November 3, 1982

Farley Nuclear Plant - Units 1 and 2
Farley Protection Upgrade Response to 10 CFR 50.48
and 10 CFR 50 Appendix R Requirements

Appendix 1 - Alabama Power Company Responses to NRC Questions During
Conversations on October 6 and October 19, 1982

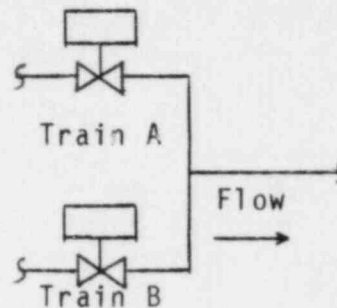
The Licensee should provide further clarification and examples in regards to his exclusion of certain components from analysis based on the "series" and "parallel" rules.

To clarify the series rule, opposite train components that are in series and are essential to establish a boundary (i.e., remain in a closed position) are not included on the Hot Standby Component List. As an example, two opposite train valves in series are shown:

Either of these valves may remain closed and still establish a boundary that is essential to achieve a hot standby condition following a postulated cable spreading room fire. To breach the boundary, an improbable series of events must occur in a hypothetical chronological scheme. The cables of opposite main components are routed in separate enclosures. A single fire in the cable spreading room must damage both opposite train, separately enclosed cables and also produce simultaneous hot shorts of sufficient voltage and current to concurrently open both valves and breach the boundary. It is the opinion of Alabama Power Company that this postulated chain of events is so highly improbable as to justify the use of the series rule.

The meaning of the parallel rule is that opposite train components in parallel legs of an essential flow path are not included on the Hot Standby Component List. As an example, two opposite train valves are shown in parallel legs of a flow path:

Either of these valves may remain open and still maintain flow in order to achieve a hot standby condition following a postulated cable spreading room fire. To impair the flow path, a single cable spreading room fire must damage both opposite train, separately enclosed cables and also produce simultaneous hot shorts of sufficient voltage and current to concurrently close both valves. As with the series rule, it is the opinion of Alabama Power Company that these postulated events are so highly improbable as to justify the use of the parallel rule.
